PAGE REPLACEMENT GUIDE FOR
AMENDMENT 70
CLINCH RIVER BREEDER REACTOR PLANT
PRELIMINARY SAFETY ANALYSIS REPORT

(DOCKET NO. 50-537)

Transmitted herein is Amendment 70 to Clinch River Breeder Reactor Plant Preliminary Safety Analysis Report, Docket 50-537. Amendment 70 consists of new and replacement pages for the PSAR text and Responses to NRC Questions.

FIGURE QCS220.5-2

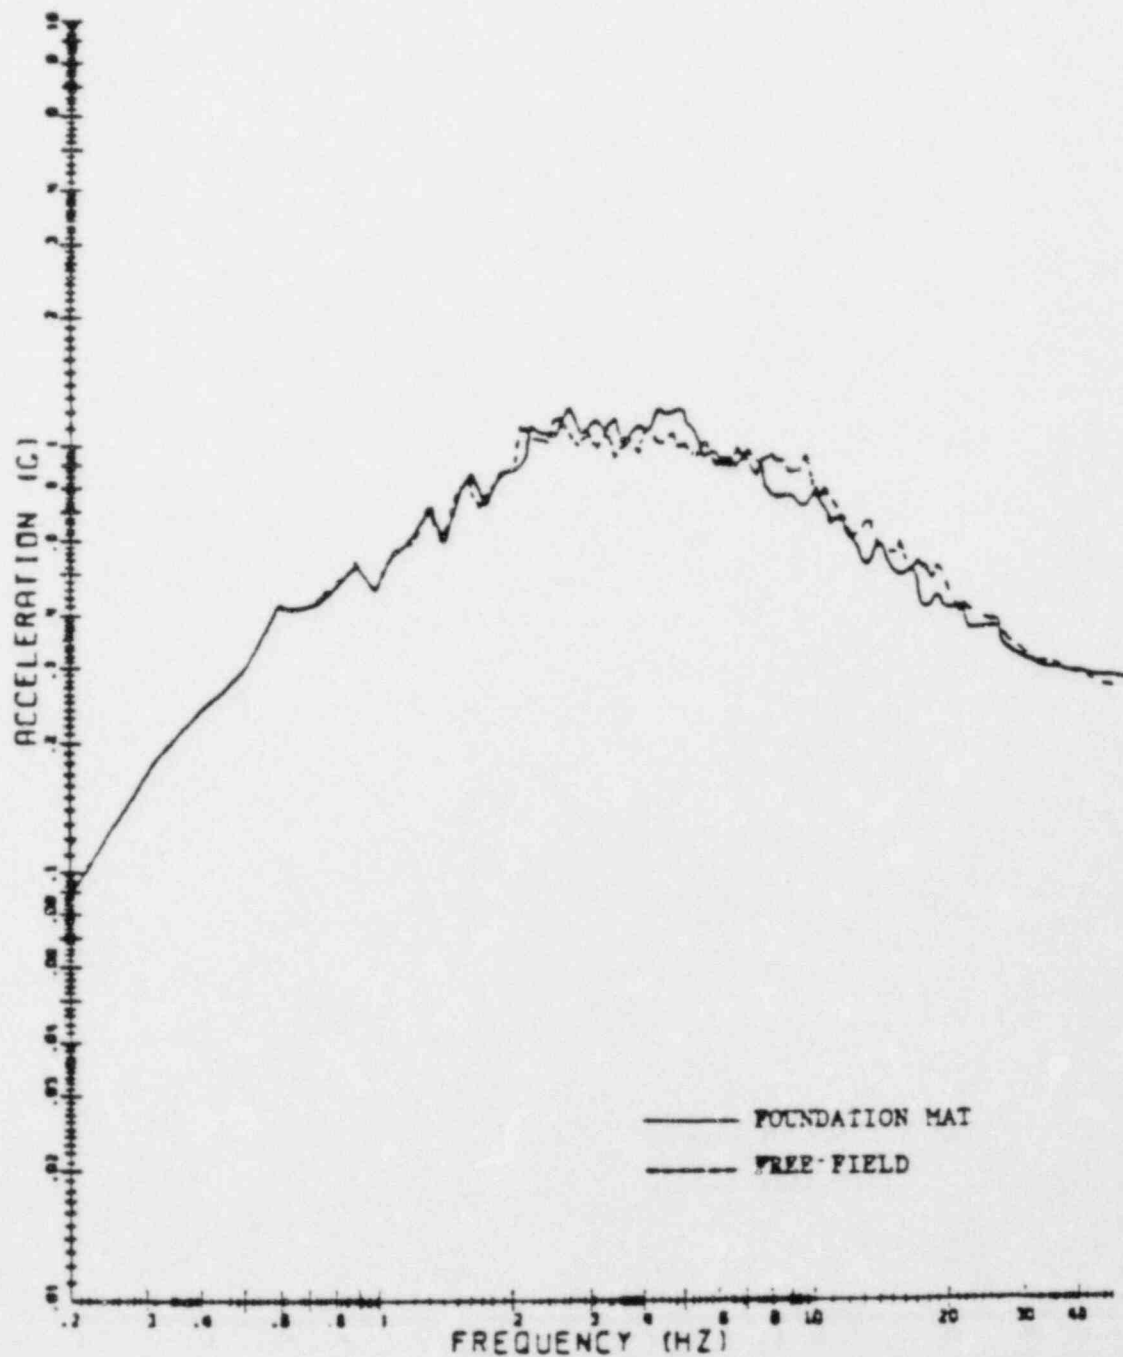
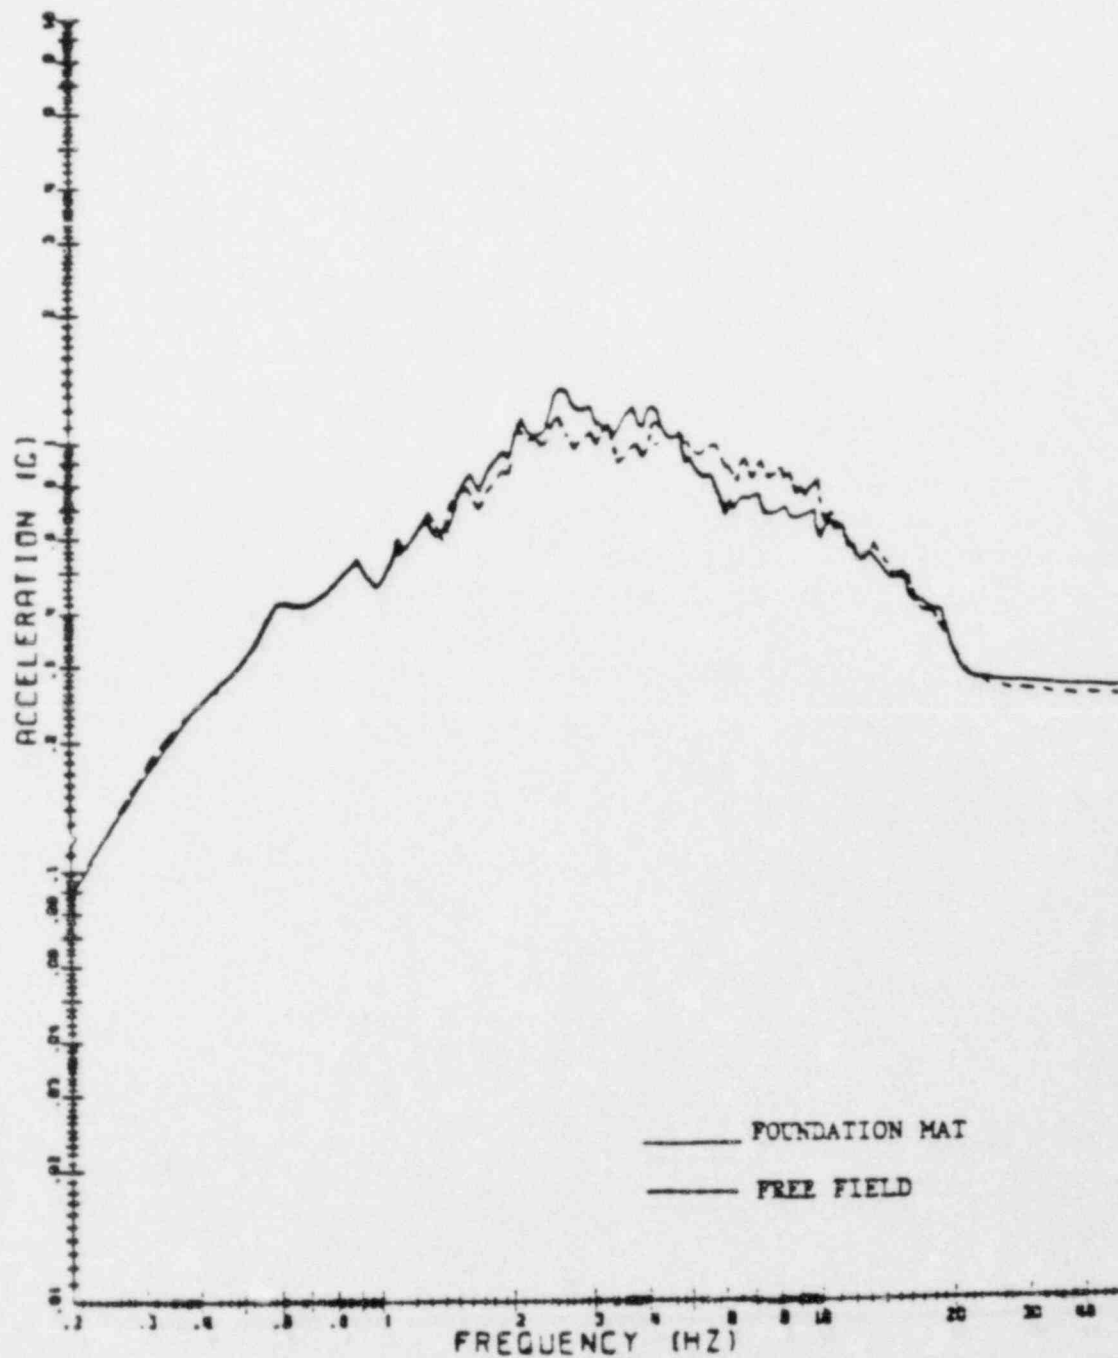
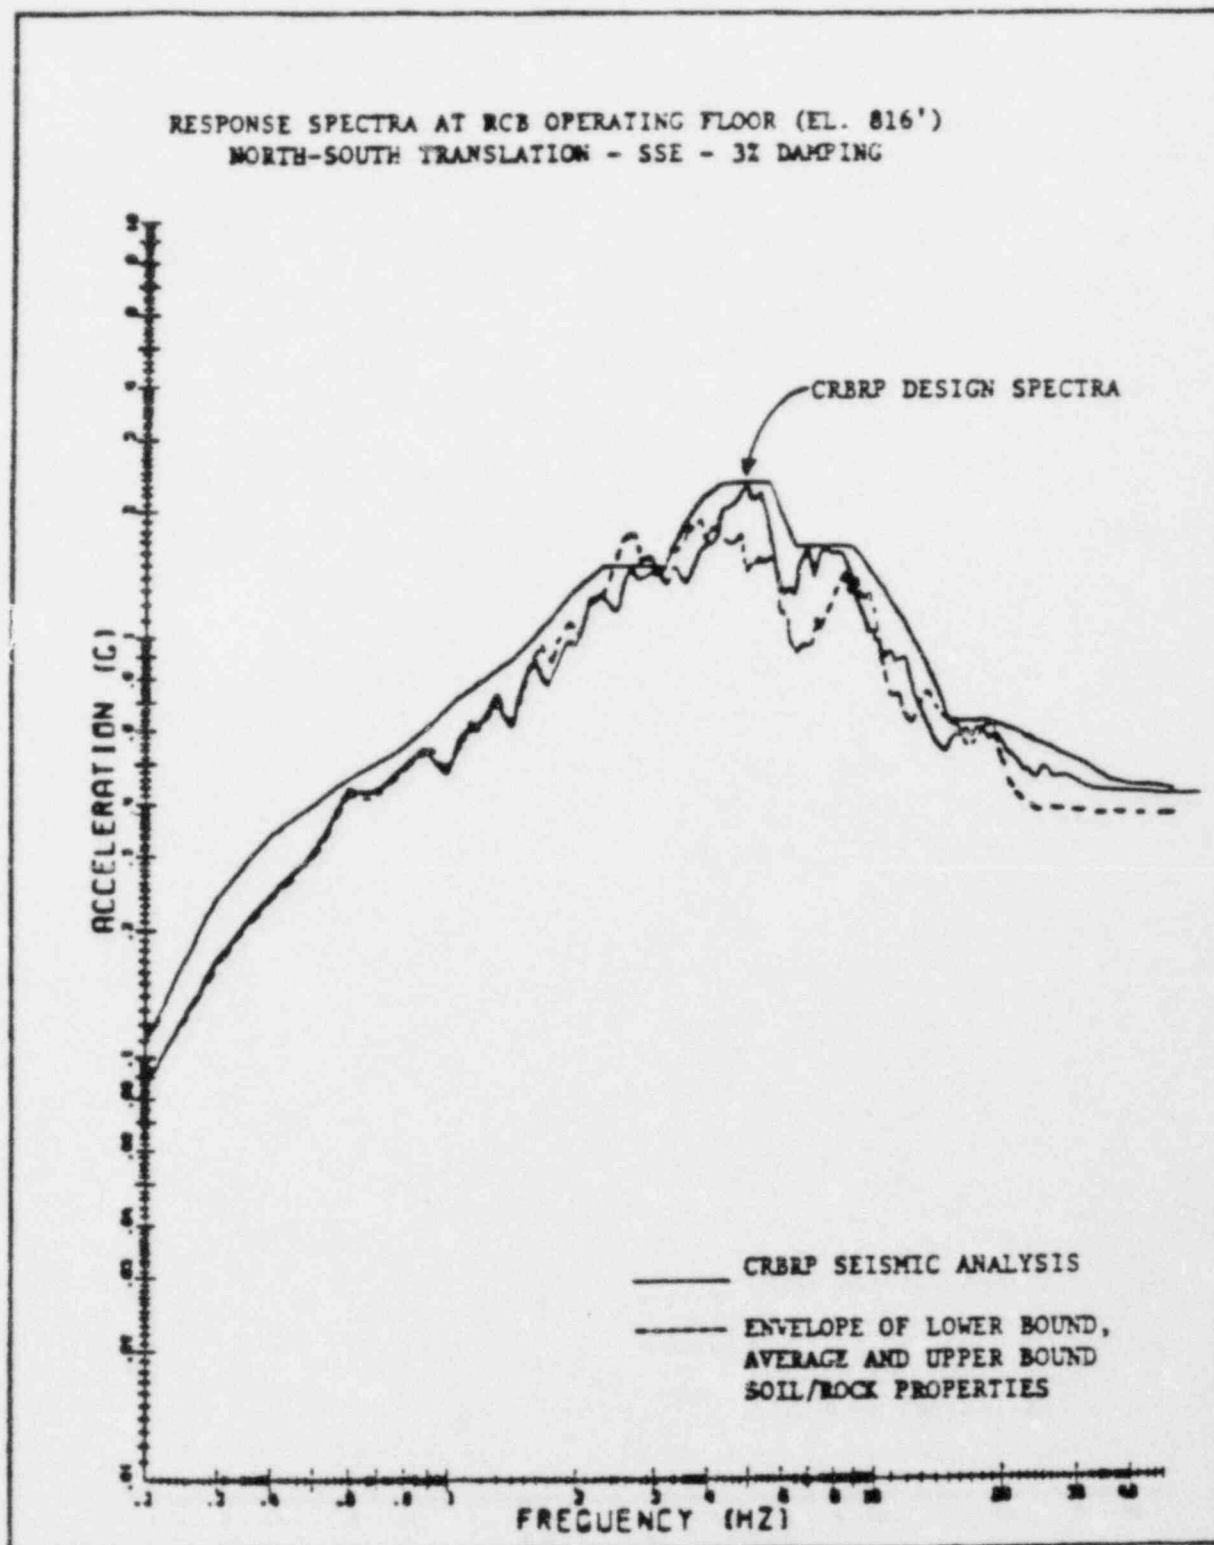
Question CS220.5

Additional analysis, using a different analytical approach (the Computer Program FLUSH) showed that the free-field and in-structure seismic responses at the foundation level differed, confirming that rock(soil) structure interaction will occur (Figure Q220.5-2).

An independent finite element analysis using the FLUSH program was performed to compare floor response spectra with the CRBRP design spectra. The CRBRP spectra in essence envelopes the calculated spectra and spectra generated from the CRBRP and finite element analyses are very similar (Figure Q220.5-3).
